Product Change Notification: CENO-30ZVLU437

CCB 7548 Final Notice: Qualification of STAR as an additional final test site and scan and pack site for selected MIC5504, MIC5361, MIC5362, MIC5365, MIC5317, MIC5366, MIC5502, MIC5524, MIC5503 and MIC5501 device families available in 4L UDFN (1.0x1.0x0.6mm) package.

CCB 7548
Pre and Post Change Summary
PCN #: CENO-30ZVLU437

Tape and Reel - CARRIER TAPE

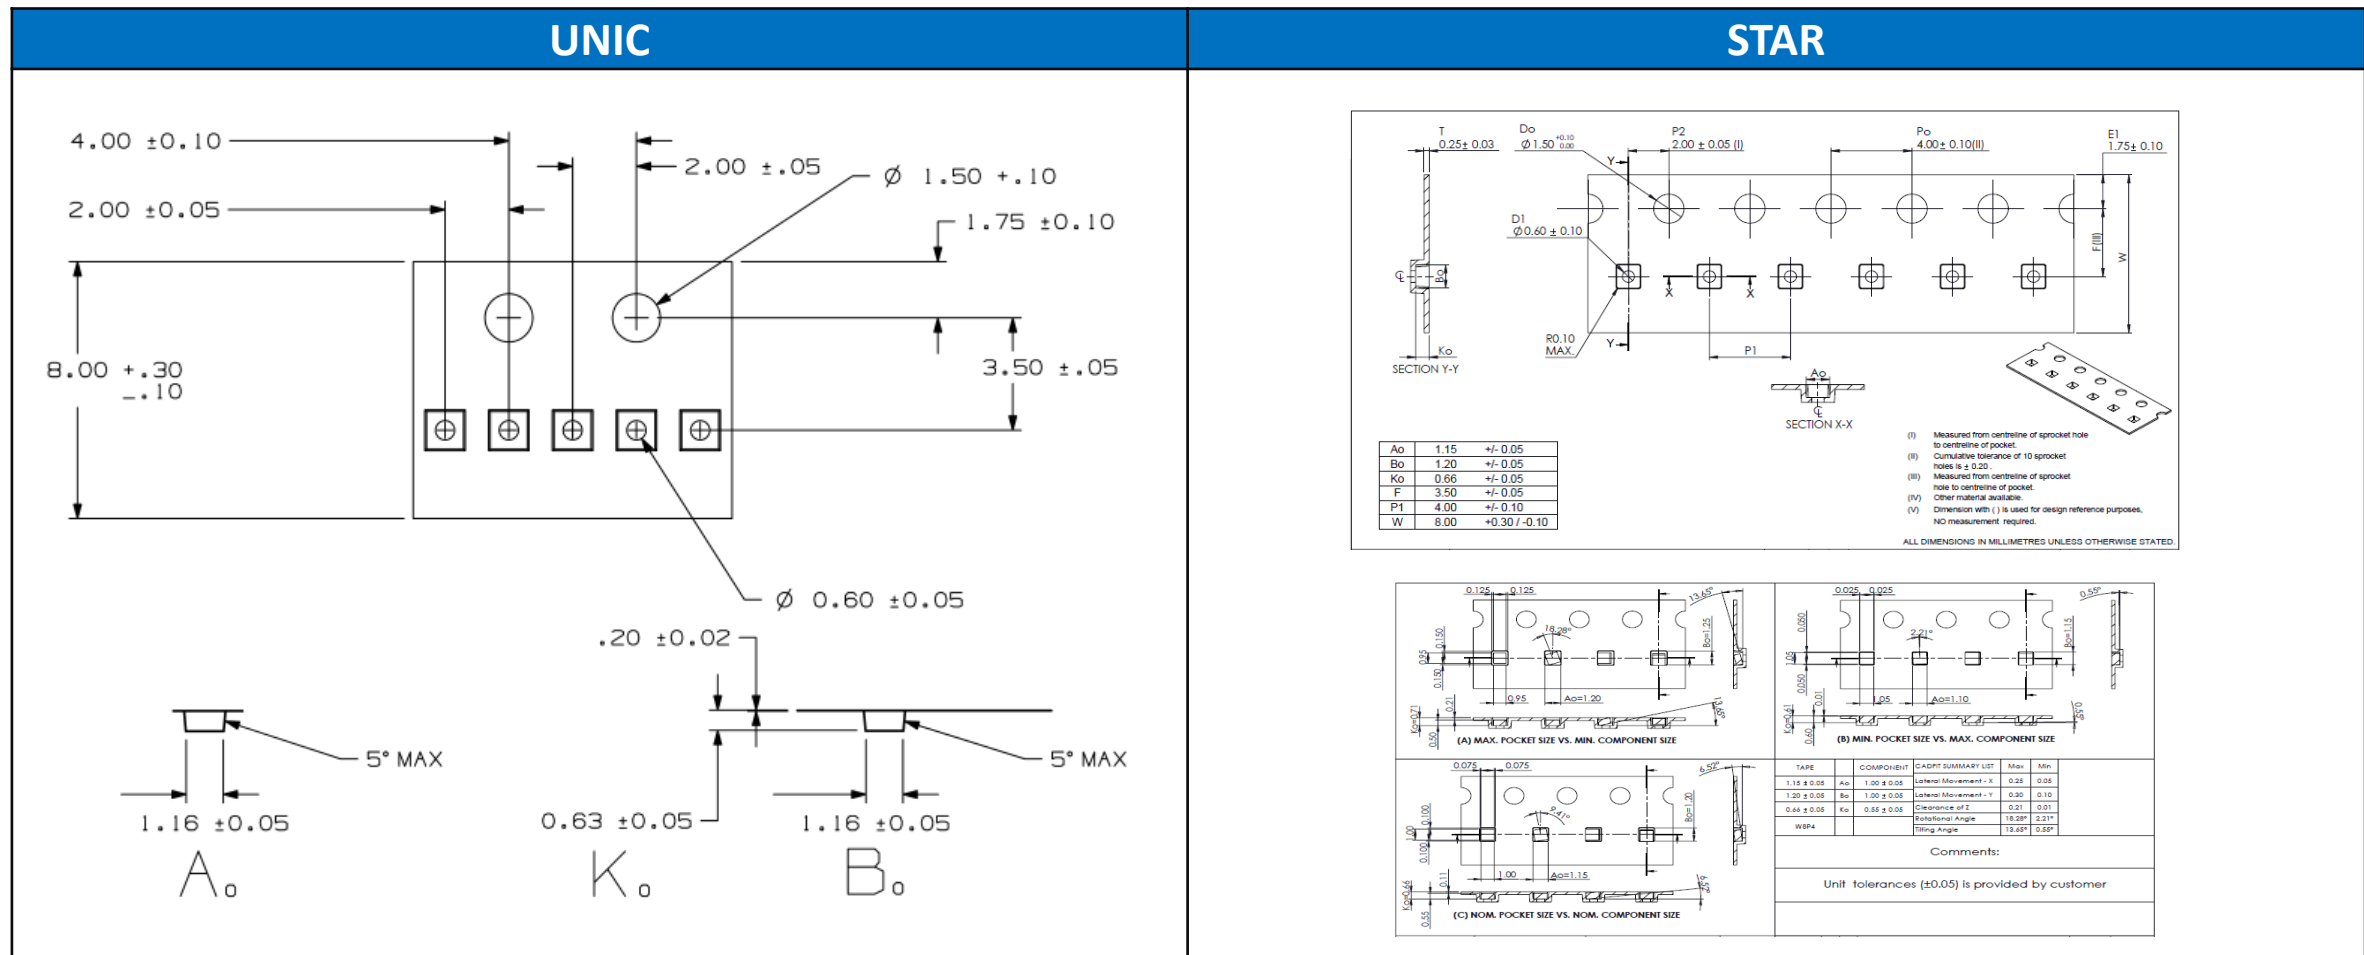
Plant	W (mm)	P (mm)	A0 (mm)	B0 (mm)	K0 (mm)	Thickness (mm)
UNIC	8.00+0.30/-0.10	4.00±0.1	1.16±0.05	1.16±0.05	0.63 ±0.05	0.25 ±0.03
STAR	8.00+0.30/-0.10	4.00±0.1	1.15±0.05	1.20±0.05	0.66 ±0.1	0.25 ±0.05

UNIC

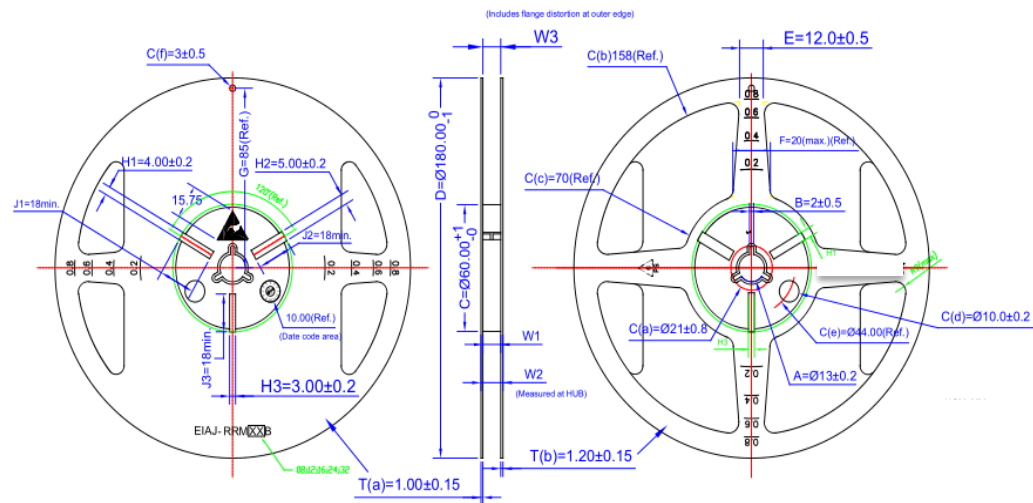
Part Number	HUB (Width)	W1 ⁺¹ ₋₀	W2 ⁺¹ ₋₁	W3
RJ708(WT/BL/BK/DBK)	8	9	11.4	9 +1.5/-0.0

Plant	Reel Diameter (mm)	Reel Hub Size (mm)	Reel Width Max (mm)	Color
UNIC	177.8	60.96	11.4	Blue
STAR	178.00±2.00	60.50± 0.5	12.40+2.0/-0.15	Dark Blue

STAR

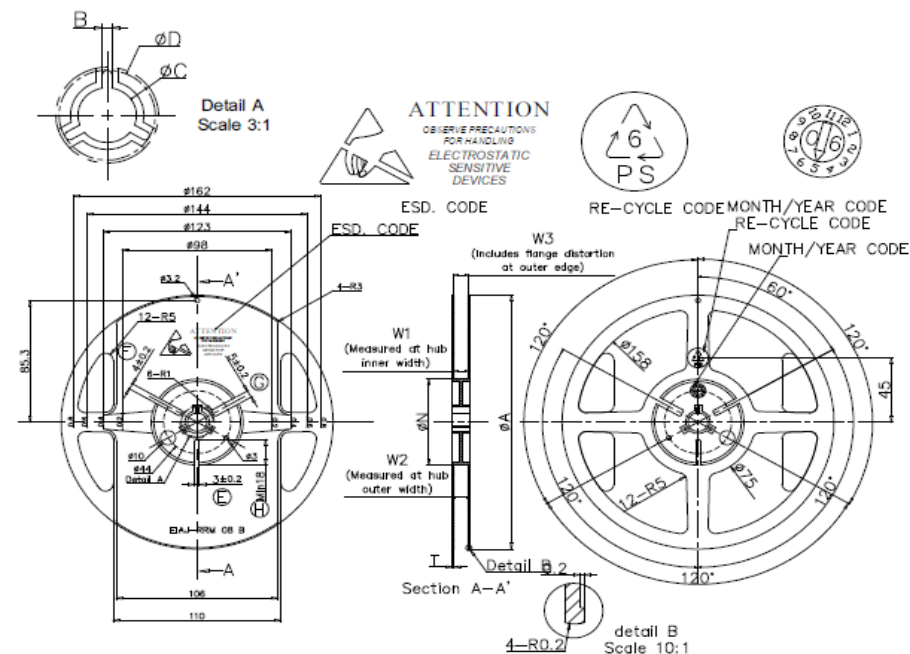
PART NUMBER	ØA ±2.00	ØN ±0.50	B $\begin{smallmatrix} +0.50 \\ -0.00 \end{smallmatrix}$	ØC $\begin{smallmatrix} +0.50 \\ -0.20 \end{smallmatrix}$	ØD ±0.20	T ±0.10	W1 $\begin{smallmatrix} +2.00 \\ -0.00 \end{smallmatrix}$	W2 (Max)	W3 (Max)
R7-12-2.4-E	178.00	60.50	2.20	13.00	21.00	1.80	12.40	18.40	Shell Accommodate Tape Width
R7-16-2.4-F	178.00	60.50	2.20	13.00	21.00	1.80	16.40	22.40	Without Interference

Tape and Reel - Packing Method

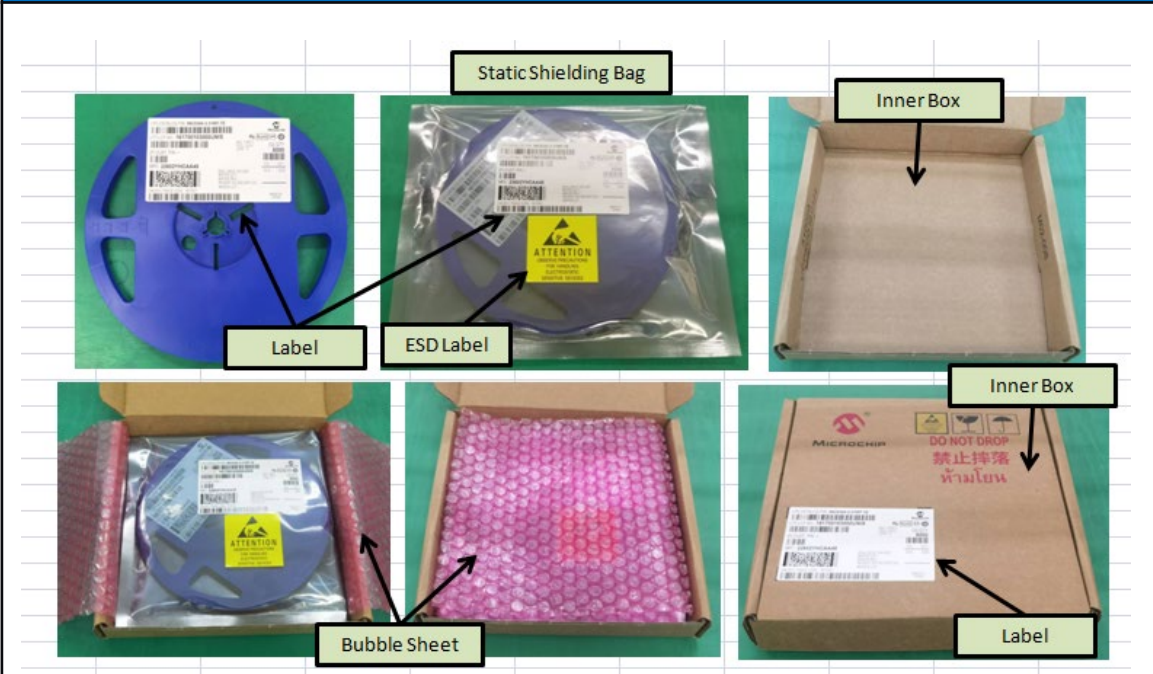
UNIC

MSL - 1

Inner box
Dimension
W x L x H (cm)
22x20.4x3.5

STAR

MSL - 1

Inner box
Dimension
W x L x H (cm)
37x35.1x5.3
